# SERVICE BULLETIN

EM19-002

April 30, 2019

## 2017 – 2018 ROGUE SPORT; AIR DUCT REPLACEMENT

Figure 1

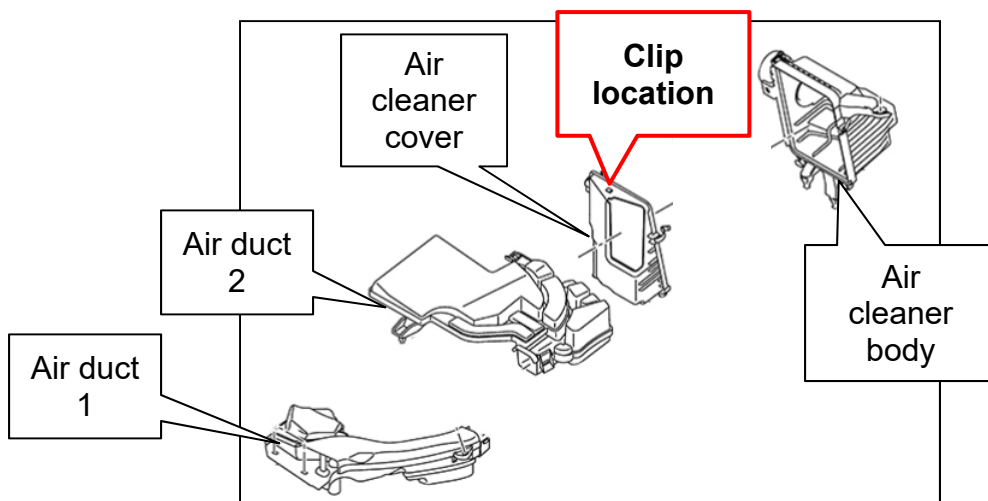
If air duct 1, air duct 2, or air cleaner cover shown in Figure 1 need to be replaced

Inspect for a clip in the location shown in Figure 1 and Figure 2.

- If a clip is present, then the vehicle **IS** equipped with the updated parts; no further action is needed. Individual parts may be replaced as needed.
- If a clip is **NOT** present, then the vehicle is equipped with older parts. See **SERVICE PROCEDURE** on the next page.

Figure 2

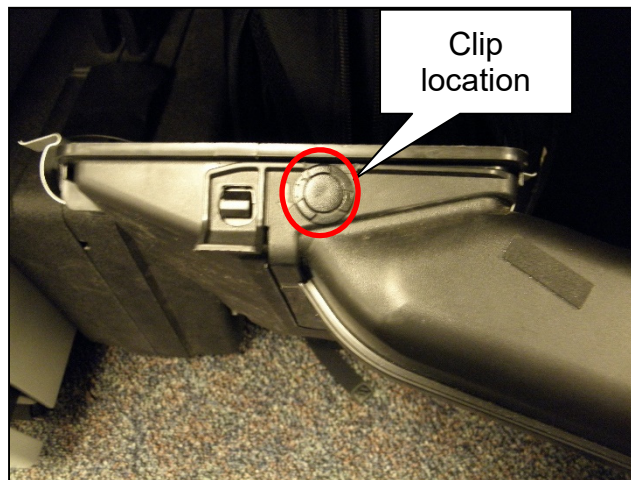
1. Inspect the air cleaner body for a clip in the location shown in Figure 2.
  - If a clip is present, then the vehicle is equipped with the updated parts; no further action is needed. Individual parts may be replaced as needed.
  - If a clip is **NOT** present then the vehicle is equipped with older parts. All components listed in the **PARTS INFORMATION** must be replaced.
    - For removal and installation, refer to the Electronic Service Manual (ESM) section REPAIR > ENGINE > ENGINE MECHANICAL > REMOVAL AND INSTALLATION > AIR CLEANER AND AIR DUCT
2. Install the new clip into the location shown in Figure 2.
